CITY OF CONWAY, ARKANSAS HISTORIC DISTRICT COMMISSION

June 22, 2026 • 5:30pm • 1111 Main Street

- A. 1419 College Ave (HDR-0526-0069) After-the-fact request for approval of a prefabricated, metal carport
- B. 1259 Ingram St (HDR-0626-0077) New single-family residence

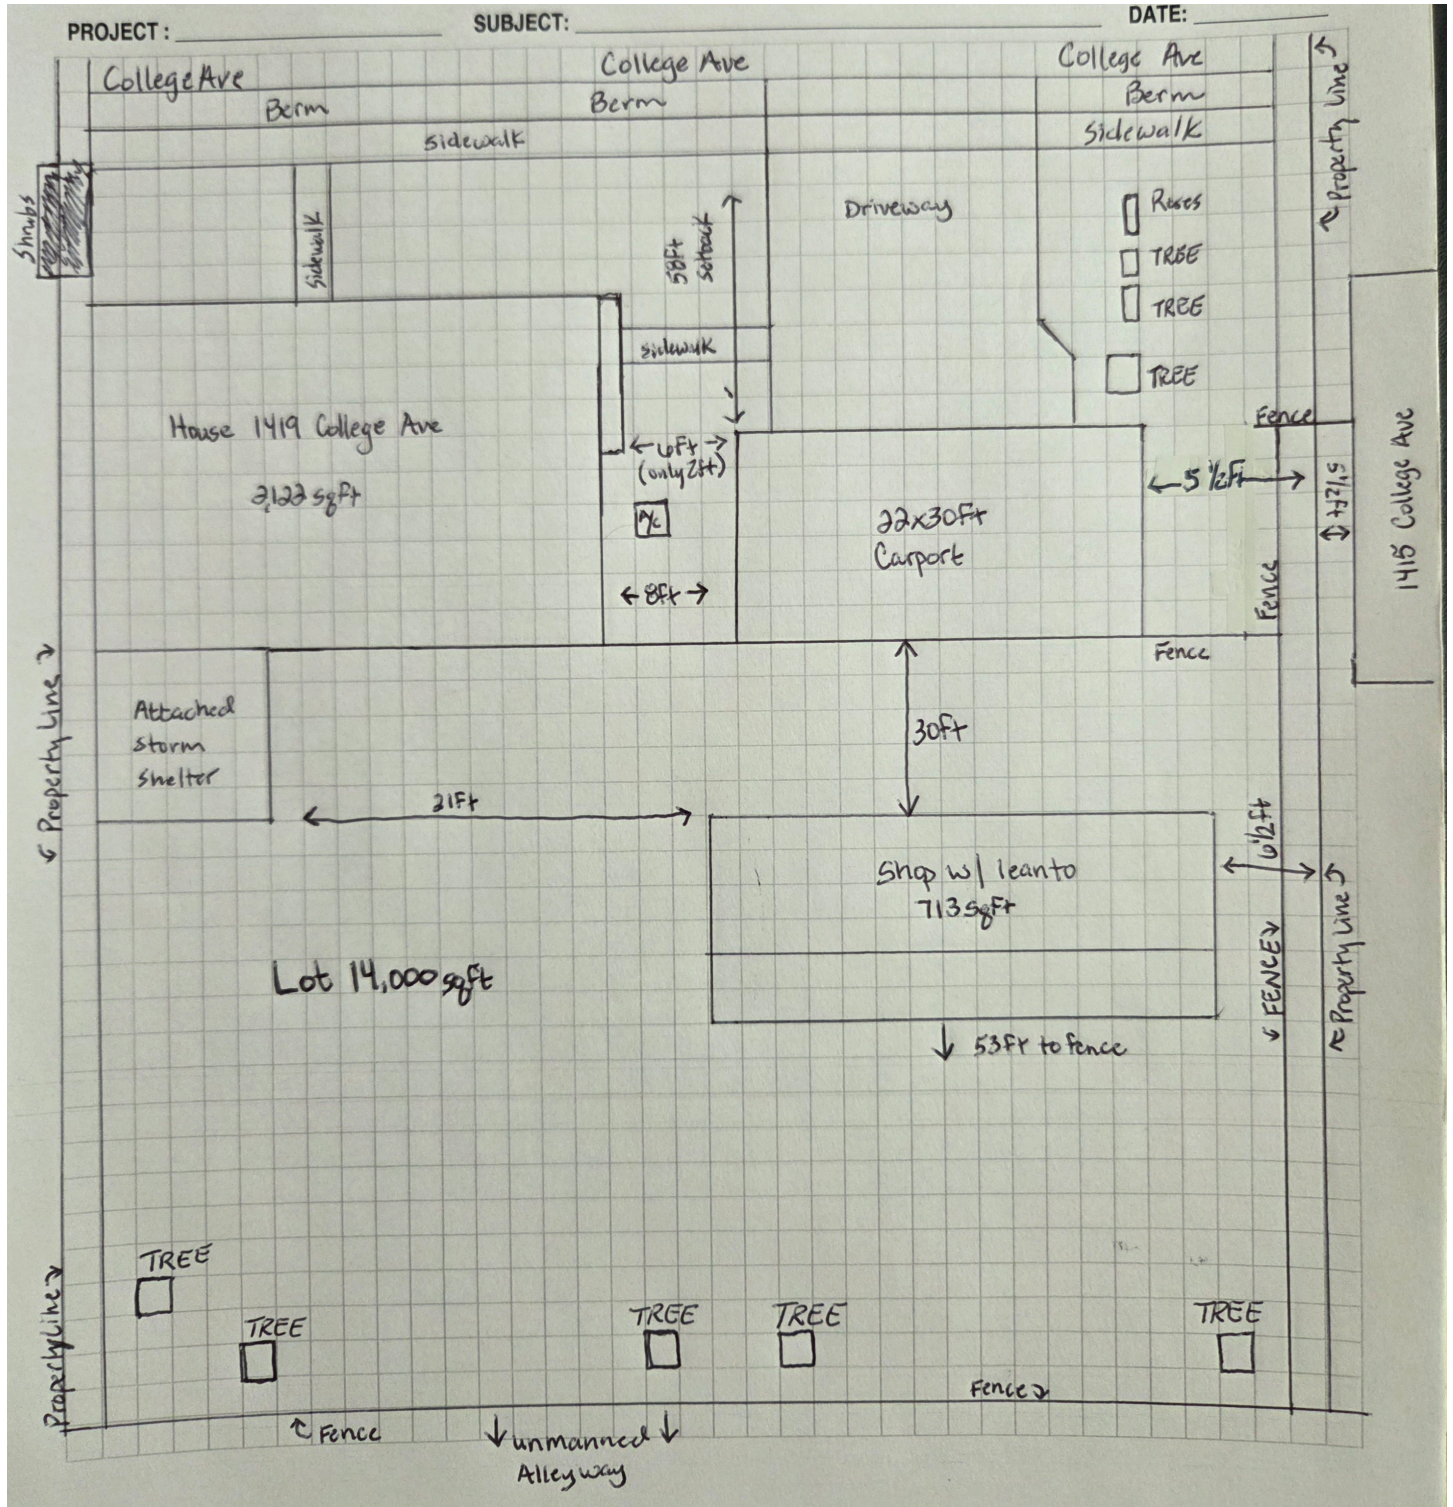
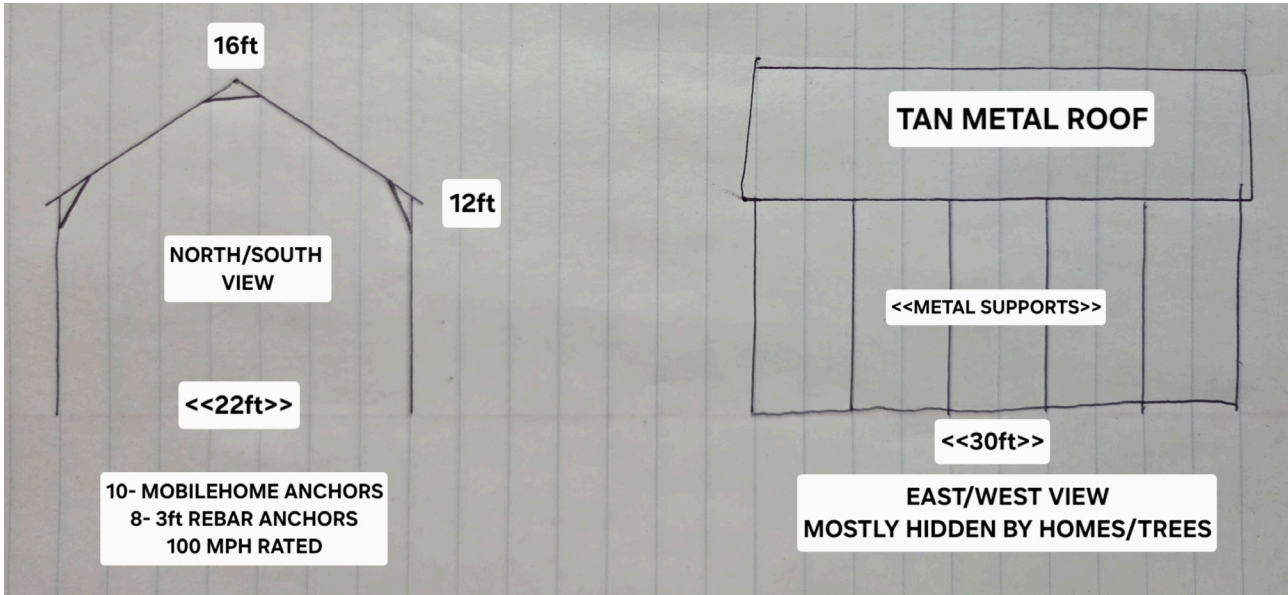
The applicant has installed the carport 6ft from the primary residence, 5 ½ft from the side property line, 58ft from the front property line, and 30ft from a detached shop.

The applicant has installed a 22'x30' metal carport visible from College Ave. The materials are not compatible with the residential structure.

There are no architectural details. The applicant has indicated that the single-family residence is 2,122. At 30% of the footprint of the primary structure, the maximum square footage for outbuildings on site is 636sf. There is an existing shop on site that is 713sf. The site has already maximized the percentage of outbuildings on site without including the new metal carport.

1. The carport shall be modified to structurally attach to the single-family residence to be considered an addition and not an outbuilding.
2. The carport shall be modified to be composed of materials that are compatible with the single-family structure.
3. Any modifications must be submitted to Planning staff for review and may require approval by the Historic District Commission.
4. Applicant must obtain all applicable building permits if/when a Certificate of Appropriateness is granted.
5. If the applicant cannot meet conditions 1-4, the carport must be removed in its entirety by August 7th, 2026.

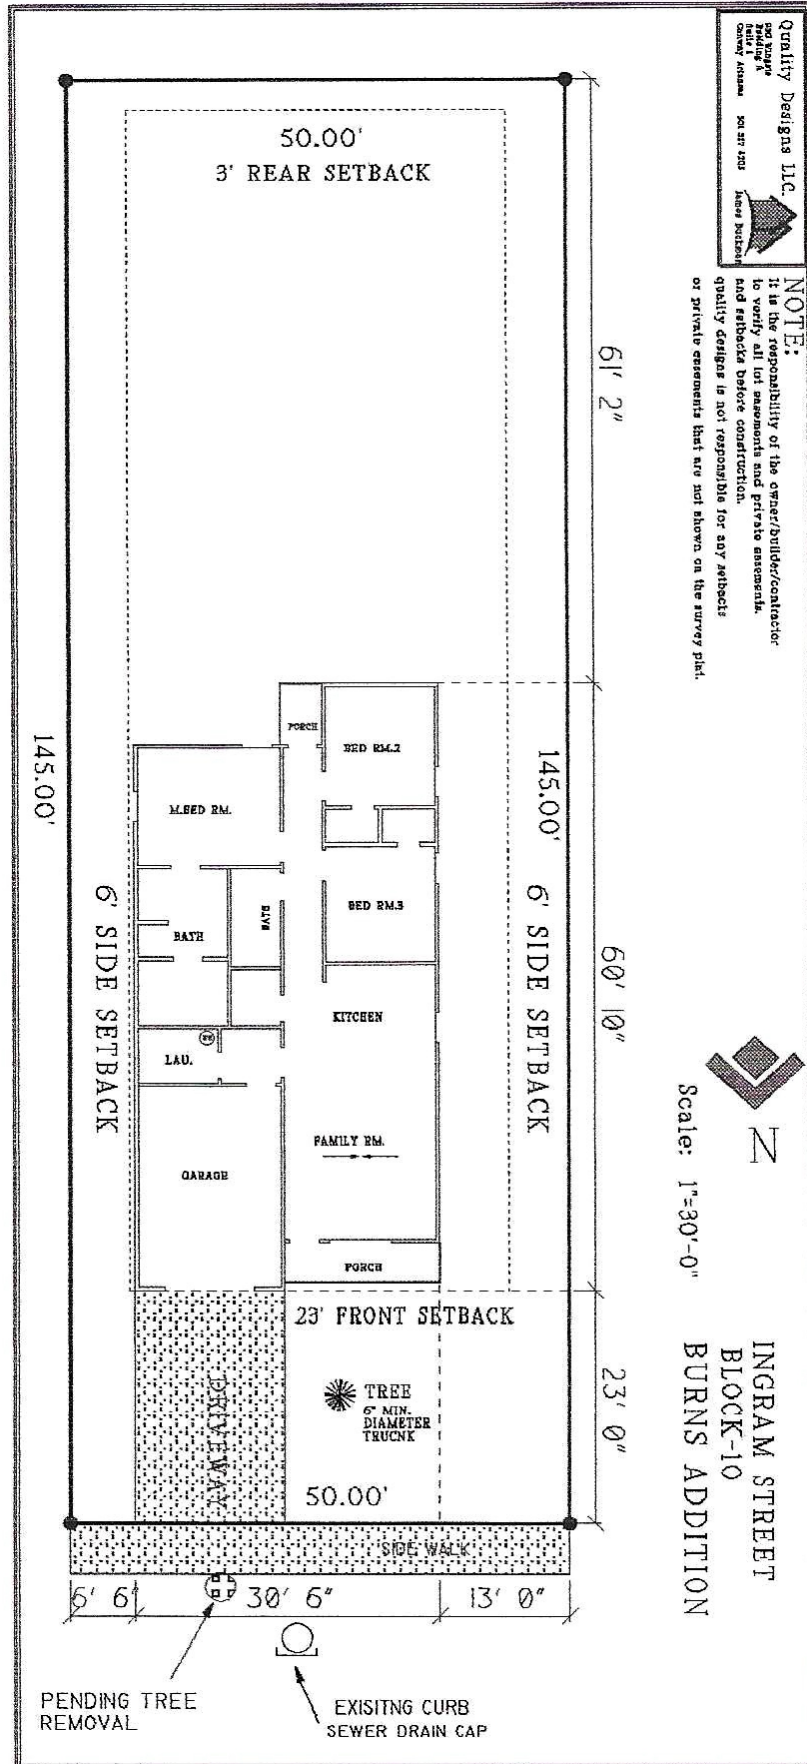
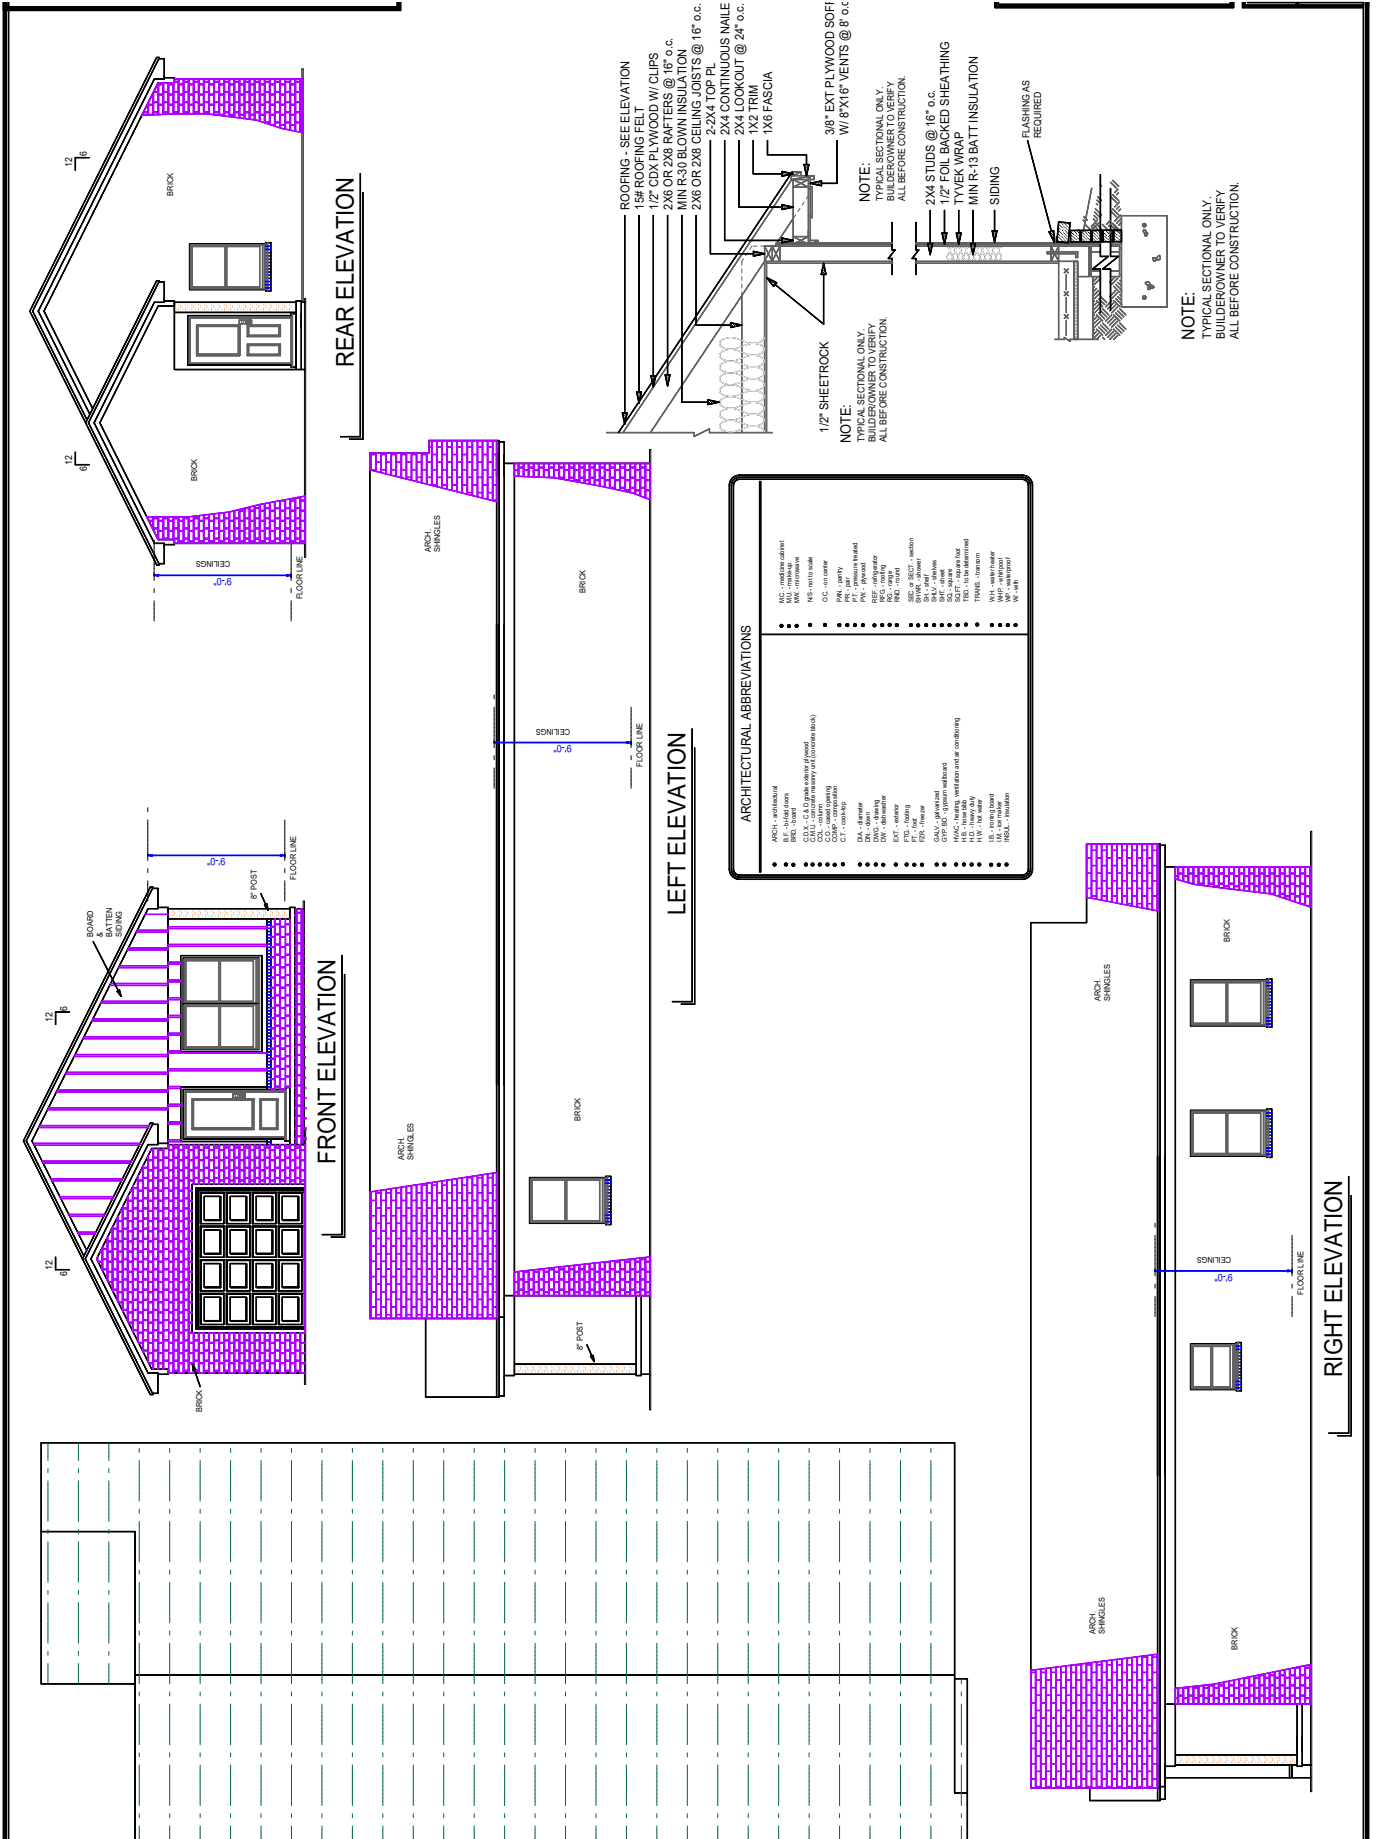
The applicant proposes an attached garage which is flush with the front façade of the residence. Based upon the configuration of the lot and residence, a detached garage at the rear appears feasible but is not proposed.

The applicant has indicated a driveway off Ingram St near the southern property line. The width and material type is not specified.

A sidewalk with greenspace is shown on the site plan. The widths are not specified.

Façade, wall area, rhythm. New facades shall be compatible with those of the surrounding area. 25-40% of front façades should contain windows. Window and door openings should relate to the size and proportions contained in the surrounding area.
The front elevation would benefit from an additional window, vent and/or dormer. It does not appear to have 25% windows on the front façade.

- Exact square footage of the proposed residence and garage
 - Depth of the front porch
 - Lot coverage tabulation
 - Driveway width and material type
 - Width of sidewalk and greenspace

- An additional window/opening on the front façade
3. Sidewalk constructed in right-of way shall be a minimum of 5' wide as measured from the property line. Greenspace shall be provided between the sidewalk and the street at a width determined by the amount of area available after accounting for the sidewalk. If there is not sufficient right-of-way to accommodate a 5' wide greenspace, a sidewalk easement shall be recorded.
